# Access Compliance Report

## Public Rights-of-Way

### (Curb Ramps)

Intersection ID: 14844	Main Street: DILWORTH_RD_WEST	Cross Street: EAST_BV	Location: SW
ADA ID: A0AAD6CFDFCC	Ramp Type: Directional1	Initial Pass/Fail: Pass	Overall Compliance: No
		Severity Score: 0.25

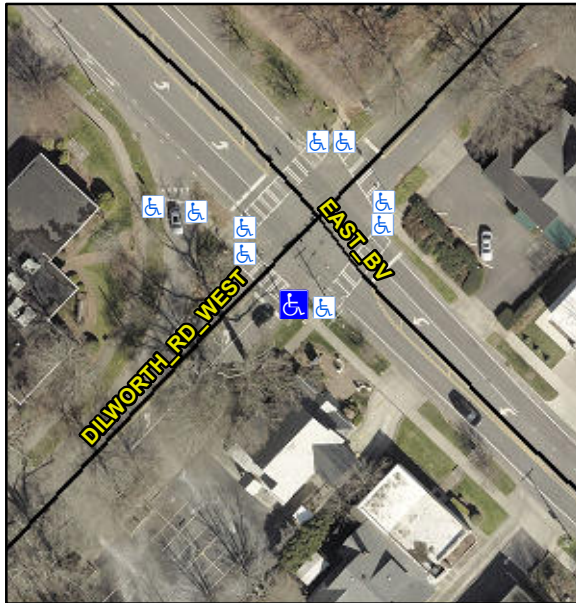
**R304.5.3**

Compliance	Description	Data	Compliance	Description	Data
N/A	Ramp Length (in)	40.0	N/A	Grade Break?	N/A
Yes	Ramp Width (in)	73.0	N/A	Grade Break Slope (%)	0.0
Yes	Ramp Slope (%)	3.5	N/A	Grade Break XSlope (%)	0.0
No	Ramp XSlope (%)	2.5			
N/A	Flare Type LT	N/A	N/A	Flare Type RT	N/A
N/A	Flare Slope LT (%)	N/A	N/A	Flare Slope RT (%)	N/A
N/A	Flare Traversable LT?	N/A	N/A	Flare Traversable RT?	N/A
Yes	Landing Length (in)	50.0	Yes	DWS Provided?	Yes
Yes	Landing Width (in)	73.0	Yes	DWS Contrast?	Yes
Yes	Landing Slope (%)	0.8	Yes	DWS Length (in)	25.5
No	Landing X Slope (%)	2.9	Yes	DWS Full Width?	Yes
N/A	Landing Curb? (Y/N)	No	Yes	DWS Offset LT (in)	0.0
N/A	Shared Landing?	No	Yes	DWS Offset RT (in)	8.0
Yes	Gutter Ponding?	No	Yes	Gutter Slope (%)	3.0
Yes	Gutter Lip Ht (in)	0.0	Yes	Gutter X Slope (%)	1.6
N/A	Painted X Walk1?	Yes		Road Slope (%)	4.2
	X Walk 1 Direction	To NW		Road X Slope (%)	0.9
	X Walk 1 Width (in)	107.0		Clear Space?	Yes

**Remove & Replace Entire Ramp.**
